Certificate of Appropriateness

Milwaukee Historic Preservation Commission/841 N Broadway/Milwaukee, WI 53202/phone 414-286-5712

2721 N. Lake Drive

JACOBS: 2721 N. LAKE DRIVE: South Side: Replacing South Sliding Door

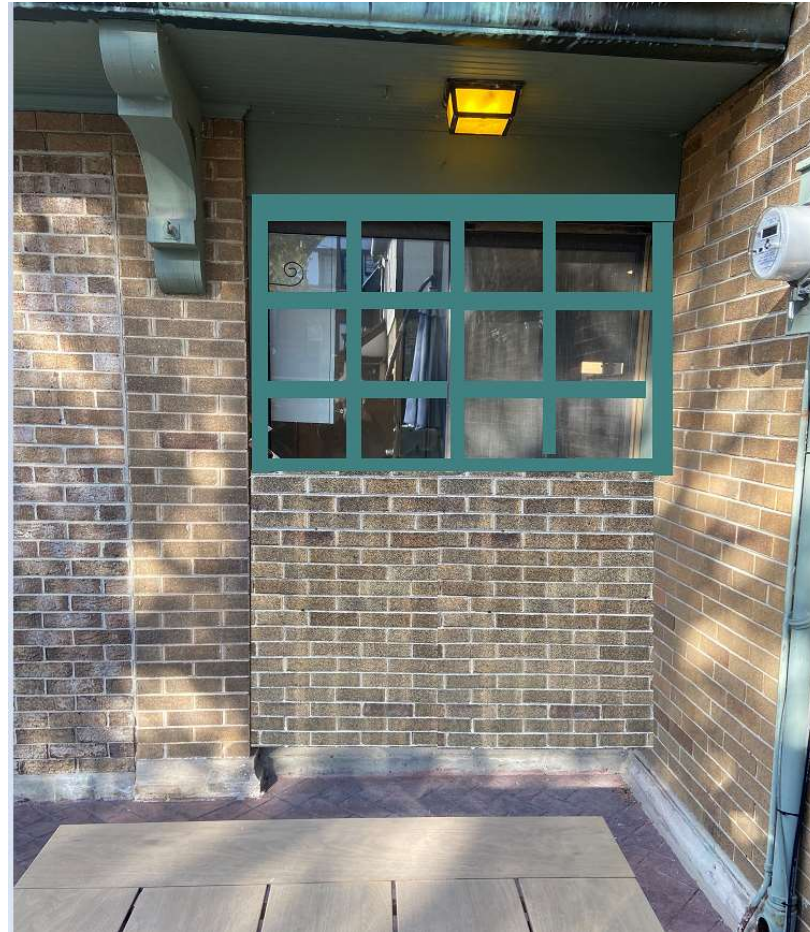
To the right of that bay is the south sliding door we are seeking approval for, clearly from a modern but unknown time. It is single pane and is does not close properly and leaks cold air.

The design of the back door with divided panes was previously approved by the HPC based upon the original doors we found in the garage.

- Remove the existing slider
- Half-height masonry using original bricks taken (and replaced with similar) from the north side of the house.
- 2 divided-light casement windows, mimicking the detail of the back door.

JACOBS: 2721 N. LAKE DRIVE: North Side: Replacing North Sliding Door:

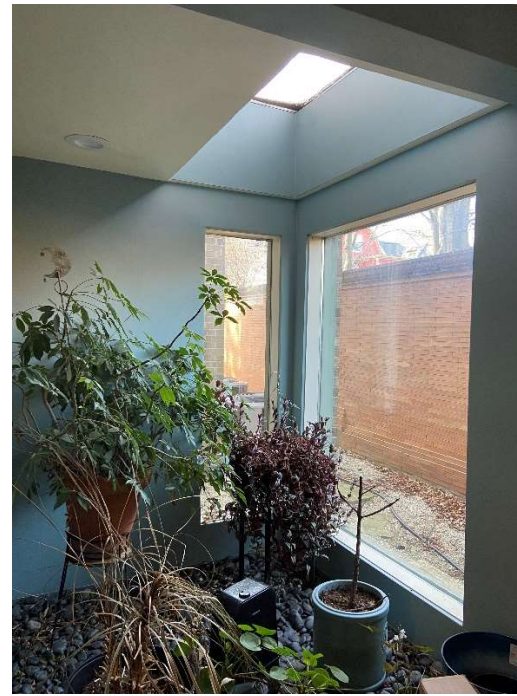
- Remove the existing slider
- Half-height masonry using bricks of a similar color/size to existing.
- 2 divided-light casement windows, again mimicking the detail of the back door

If required, the existing 2 vent locations seen in the photograph (stove & oven) will be filled in with bricks and moved as required to vent the stove/ovens. It is hoped (but cannot yet be confirmed) that the existing outlets may be used. If they need to be moved, the vents will be of approximately the same size.
